**CERTIFICATE OF APPROPRIATENESS**

**Property:** 1715 Bismark Street (also 705 Sabine St), Tracts 8A & 9, Lot 442, Renner Neighborhood Subdivision. The property includes a historic 783 square foot, one-story wood single-family residence situated on a 6,230 square foot (63.6' x 100') interior lot.

**Proposal:** New Construction: 2-Story Single Family Residential

Proposed Site Plan

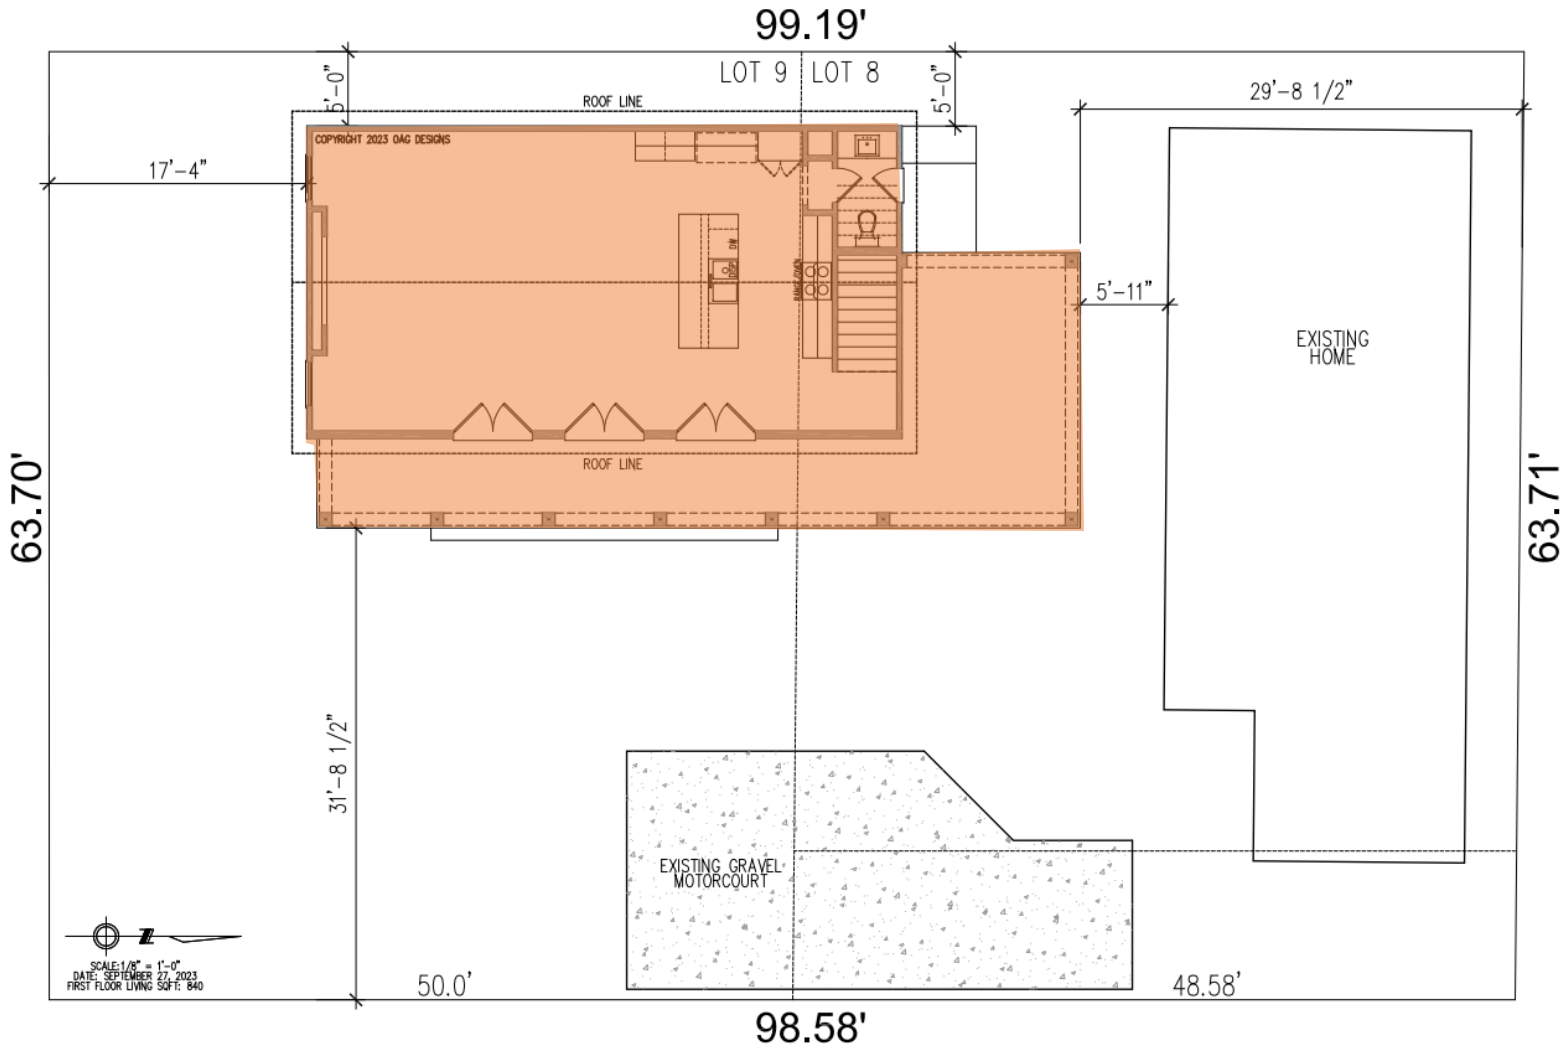
Front setback 32' 8-1/2"; South side setback 17' 4"; Rear setback 5'. The proposed setbacks are appropriate as are set back greater than typical contributing structures. This keeps the new construction more to the rear and center of the lot.

Proposed Front (East) Elevation

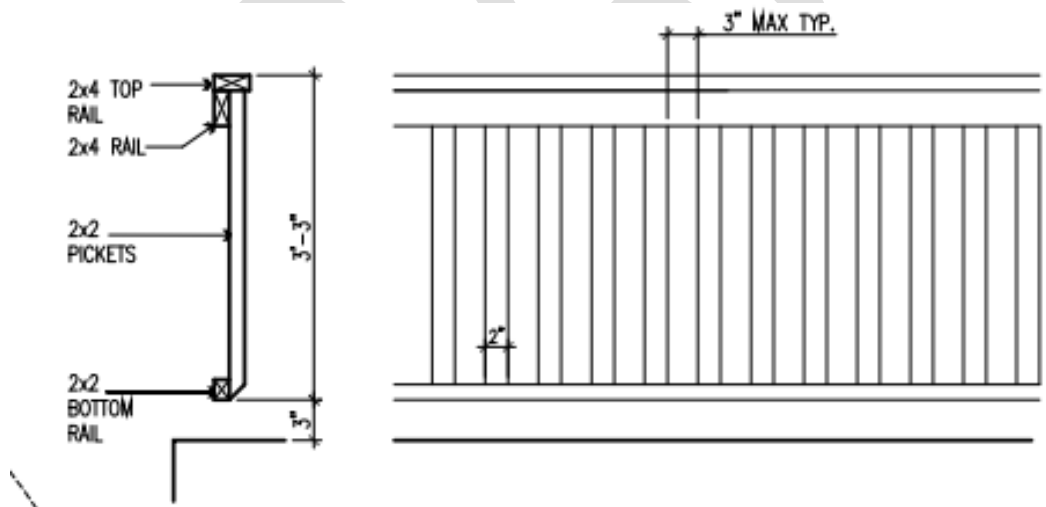
- In accordance with Sec. 33-276, the proposed activity must comply with the City Council approved Design Guidelines. Proposed dormers comprise less than 10% of the building's footprint (p.30) and are taller than wide, properly proportioned similar to a window. (p.35) Front porch depth meets minimum 6' requirement (p.14)
